R22

SERVICE LETTER #42

SUBJECT: Replacement of Inlet Ducts

ROTORCRAFT AFFECTED: R22 Helicopters S/N 0002 thru 2151, unless overhauled at the RHC factory after 09 June 1992.

FIGURE 1

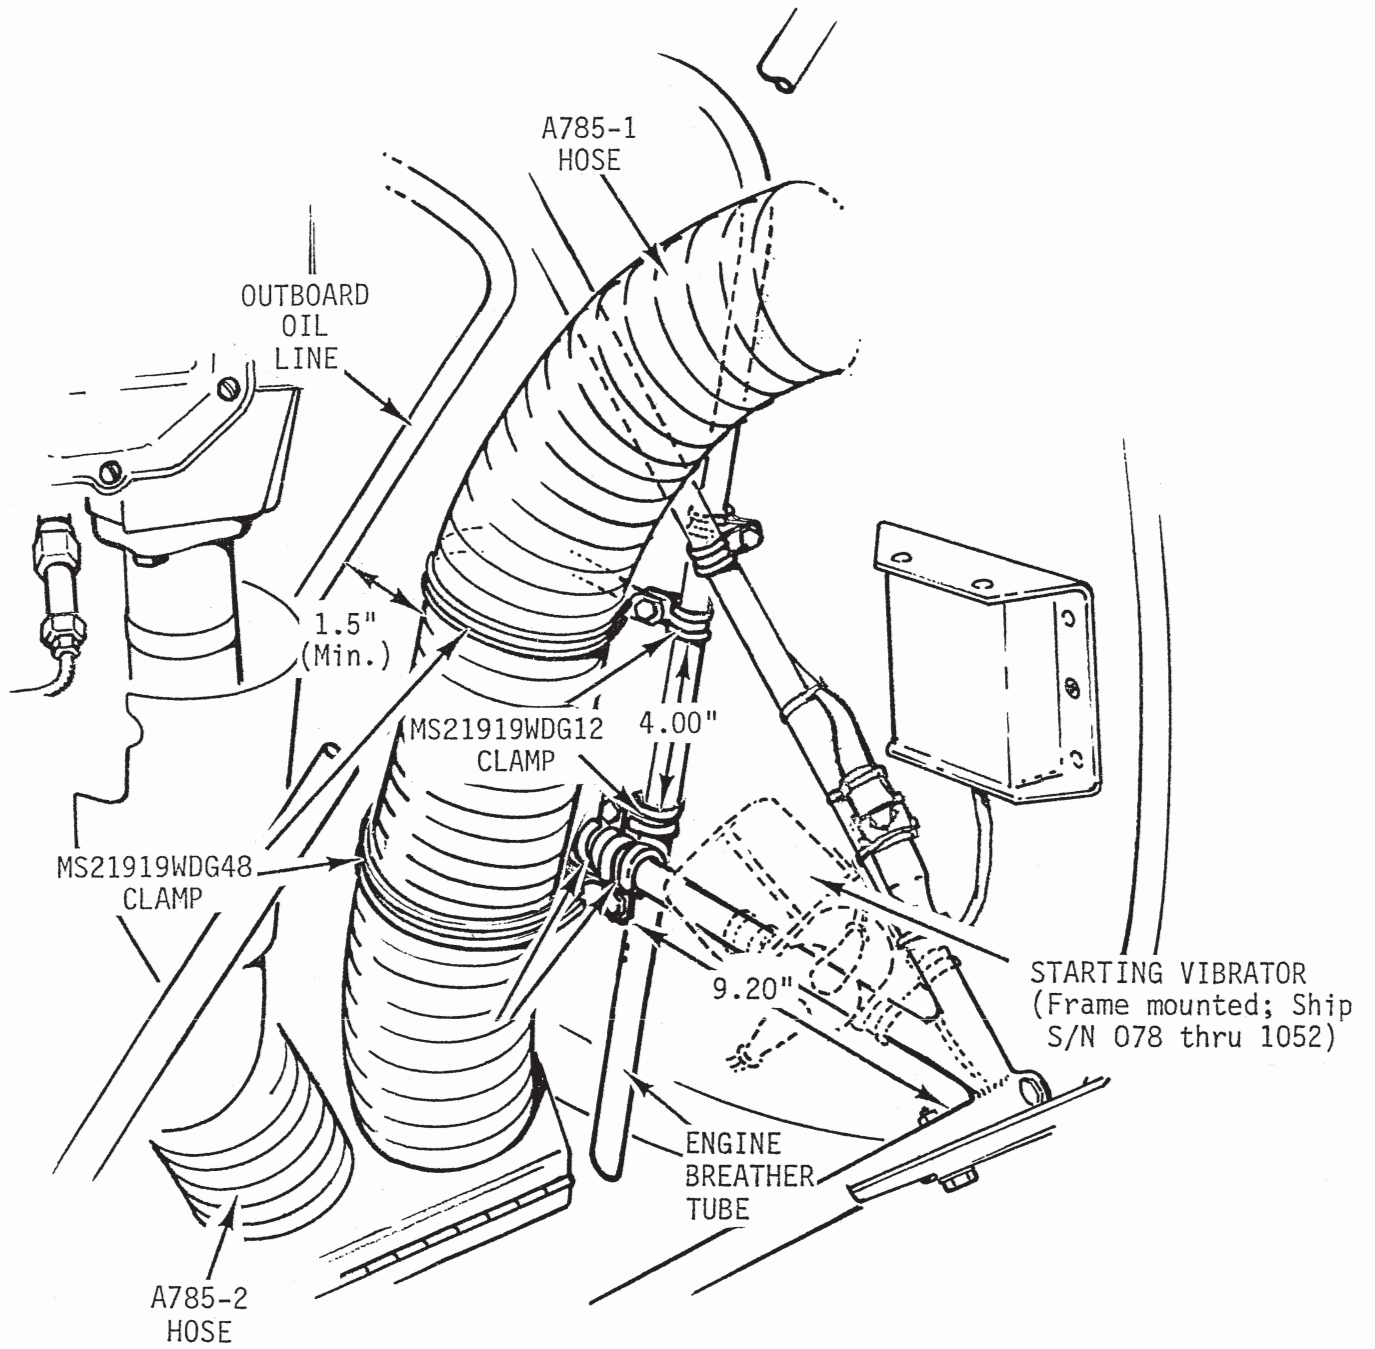
BACKGROUND: An improved inlet duct material has been developed and is now available. The new ducts will be more corrosion resistant, reliable, and will last longer. To encourage their immediate installation, RHC is discounting their price by 60% if ordered before 31 July 1992.

1. Order A785-1 and A785-2 Rev K or later replacement hoses from RHC Customer Service.
2. Removal and installation of A785-1 and A785-2 hoses.
Loosen B277-36 clamps on A785-2 hose together with B277-48 clamps on A785-1 hose. Remove A785-2 and A785-1 hoses by twisting them down. Install new A785-1 and A785-2 hoses verify carb air scoop secured. Verify 1.5 inches minimum clearance between A785-1 hose and A723 oil cooler, ref Fig 1. CAUTION: Be sure ducts are firmly clamped at both ends.
